PUBLIC HEARING/WORKING SESSION MEMORANDUM

PETITION #301-21

386-394 Watertown Street

PUBLIC HEARING MEMORANDUM

Graphic I: Vehicle Exiting Stall #14

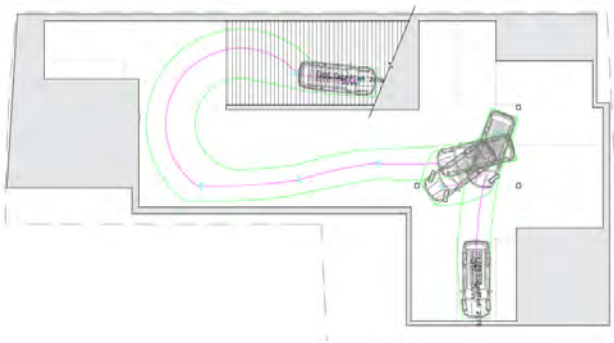
Both parking areas contain end-parking stalls that are restricted on one or both sides. As a result, the Planning Department asked the petitioner for templates demonstrating how vehicles would maneuver into and out of the stalls. The petitioner provided the below templates indicating a vehicle would require an additional maneuver to exit stall #14, while an additional maneuver would be necessary to enter stall #15.

There are other end-parking stalls proposed, #s 5 and 6 (in the At-grade facility), and #s 9, 10, 11, 12, 13, and 16 (Below-grade facility) and staff has asked for those templates. Given the additional maneuvers likely necessary for these other end-parking stalls, the Planning Department suggests the petitioner consider removing parking stalls in exchange for some other strategy or improvement such as shared parking, weather-proof, secure bicycle parking or similar tenant amenity, or additional landscaping.

Graphic III: Below-Grade Parking Garage

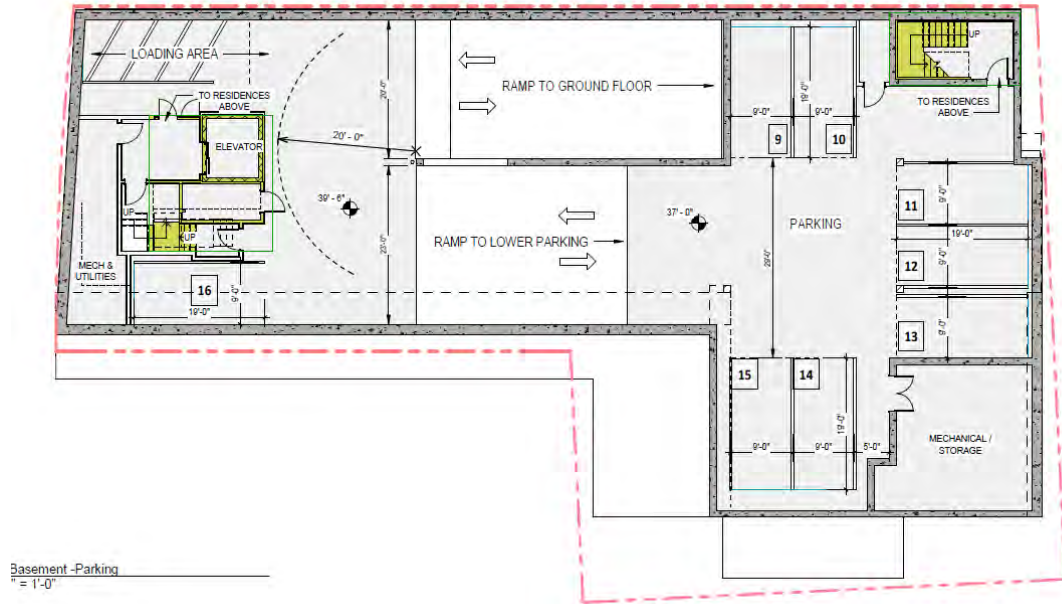
Given the presence of metered parking in Nontanum and the effort to reduce the number of vehicles using the ROW, the Planning Department suggests the petitioner consider removing parking stalls dedicated for guests to allow for creating weather-proof, secure bicycle parking or similar tenant amenity, additional landscaping, or other improvement.

The Revised Project includes altering the at-grade parking facility to allow for a ramp down into a below-grade garage containing seven parking stalls and one loading area. As designed, the garage requires waivers for drive aisle width and for the maneuvering space of restricted-end stalls which results in tight maneuvers for vehicles (parking stalls in the at-grade facility also require a special permit to waive the maneuvering area). Staff understands these maneuvers would be conducted by residents, yet staff

has asked for additional turning templates, which will be reviewed by the Engineering Division. Additionally, the petitioner should confirm how vehicles exiting the below-grade garage would be alerted to vehicles entering the below-grade garage or circulating above in the at-grade parking facility.
